**CALIFORNIA REGIONAL WATER QUALITY CONTROL BOARD  
LAHONTAN REGION**

**MEETING OF MARCH 9-10, 2022  
VIDEO/TELECONFERENCE**

**LEVIATHAN MINE UPDATE**

Thank you for the opportunity to comment on Atlantic Richfield Company's (AR) August 6, 2021, *Focused Feasibility Study for OU-1 Mine-Influenced Groundwater and Metals in Surface Water* for the Leviathan Mine Site. The California Regional Water Quality Control Board, Lahontan Region (Water Board) staff have the following comments, offered to support the development of a mutually acceptable focused Feasibility Study (FFS), Proposed Plan and Record of Decision for the implementation of an Early Final Remedial Action (EFRA) for OU-1. To that end, Water Board staff have, and will continue to work with the United States Environmental Protection Agency (USEPA) and AR to resolve remaining issues. Water Board staff look forward to fulfilling our role as the lead support agency as defined in CERCLA.

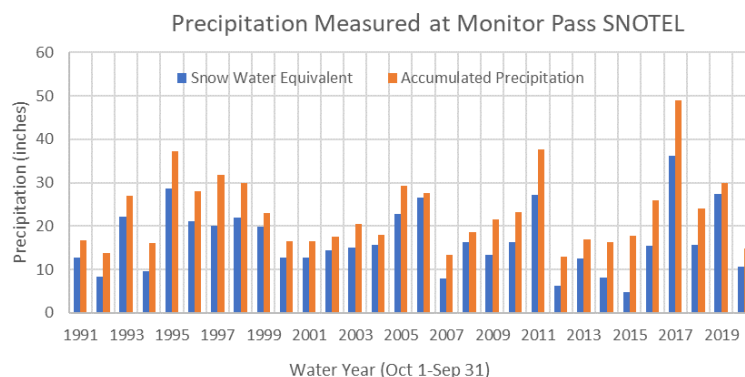
Review of the groundwater report and data from the site indicate that the validity of this conclusion has not been demonstrated based upon:

- Insufficient number of downgradient bedrock wells
  - Only 2 bedrock wells downgradient of mine waste in the Leviathan Creek watershed (PZ-07 and MW-41)

- Only 2 bedrock wells downgradient of wine waste in the Aspen Creek watershed (MW-44 and MW-42: high sulfate concentrations in MW-44 are discounted because of anomalous water levels and MW-42 has pH 10 suggesting poor well construction)

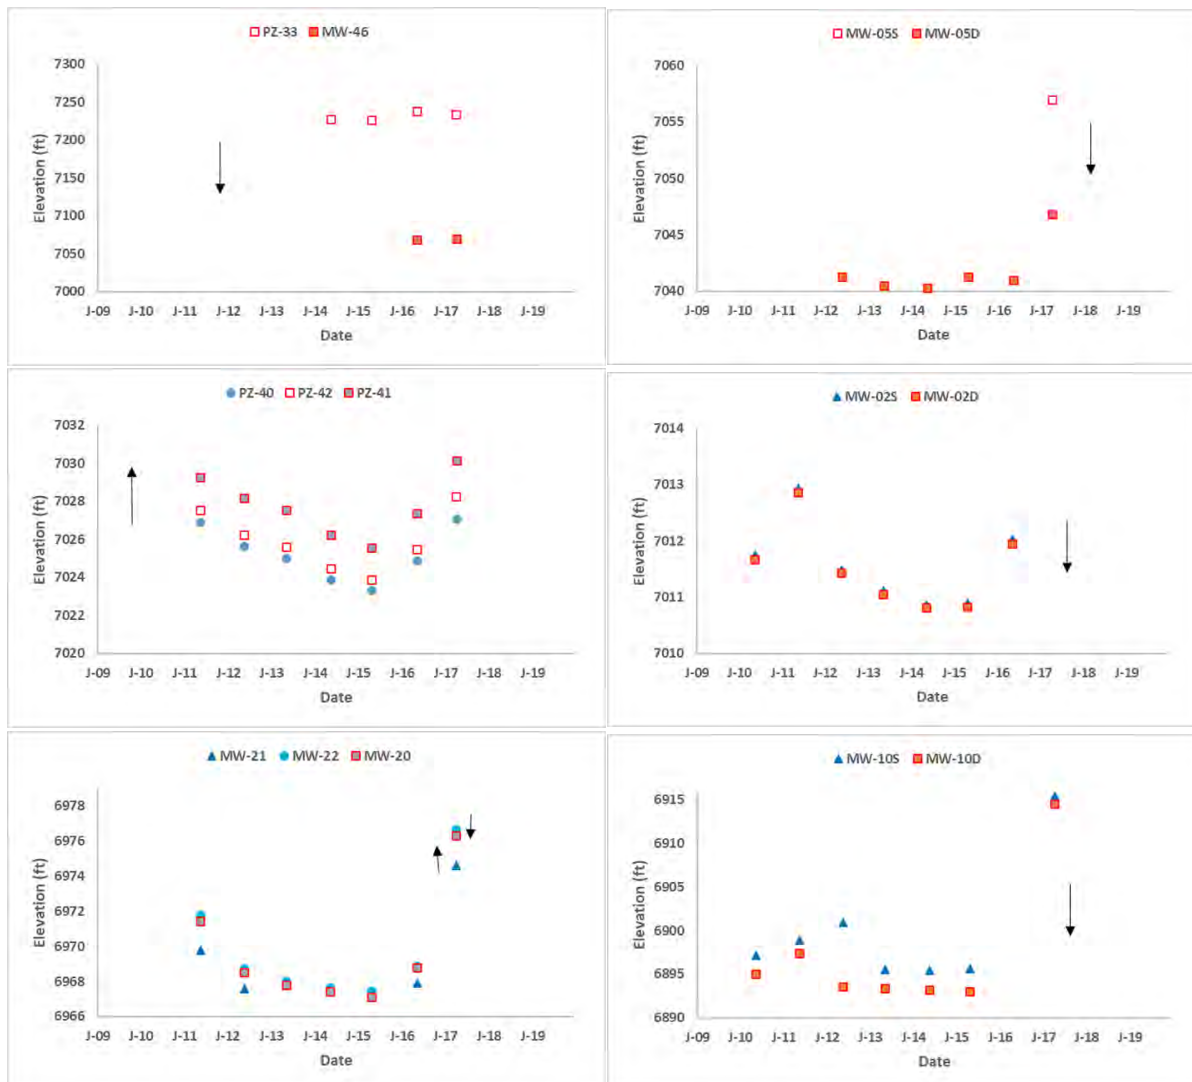
- Most nested wells that penetrate the bedrock show downward vertical gradients indicating groundwater recharge to the bedrock aquifer. Recharge to the bedrock aquifer indicates groundwater flow in the aquifer.

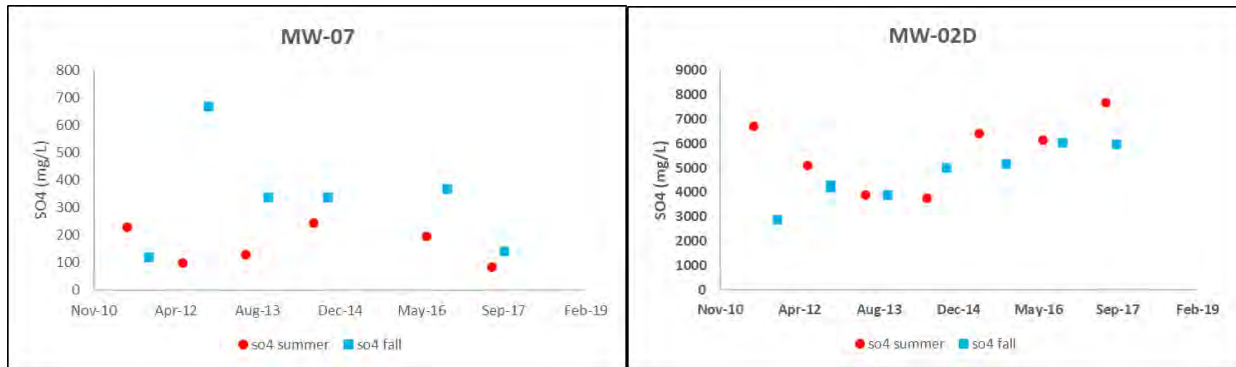
- The upgradient flow rate, which is estimated to be between 13 and 21 gpm (Table 9, pg 55, August 19, 2020; Table 10, pg 56, January 22, 2021), is only for flow into the mine waste and is based upon the assumption that all the groundwater in the mine waste is captured by the locations where flow is measured (Adit, PUD, CUD, Delta Seep, Aspen Seep). If there is uncaptured (not measured) flow, then the upgradient flow into the water budget is underestimated. Other methods to estimate upgradient flow into the mine waste should be used and estimates compared with the regression analysis used in the current version of the water budget.

- Additional work should be conducted to assess groundwater flow in the intermediate groundwater flow system (aquifer) and its connection with the overlying mine waste. The intermediate aquifer is described in the Amec Foster Wheeler Site Characterization Report Appendix B Groundwater Technical Data Summary Report (Section 2.2.5). This aquifer includes Tertiary volcanic and volcanoclastic units, which underlie the local aquifer of mine waste and naturally occurring alluvial materials.

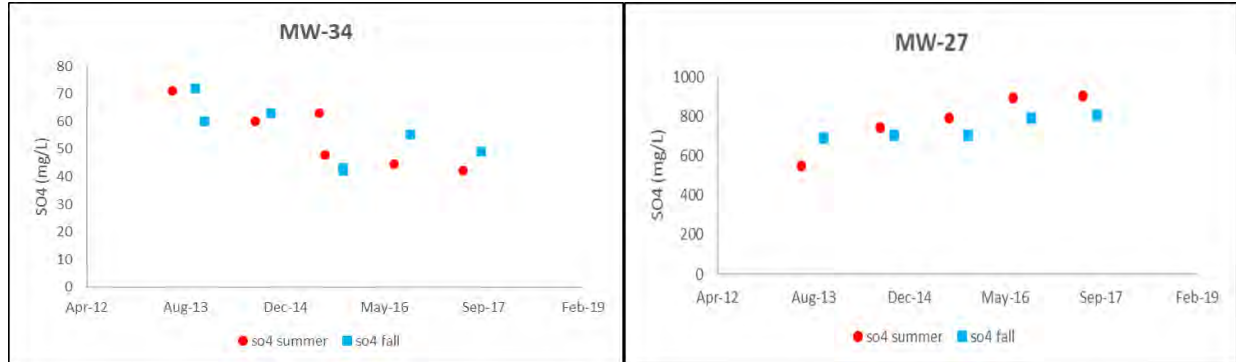
- Variation in acid mine drainage contaminants of concern concentrations (and/or loading) between record wettest water year and normal (or average) year, and/or drought conditions is not presented. The record wet year in 2017 likely results in dilution of contaminants. (Note this is the opposite of what happens in some cases, see below).
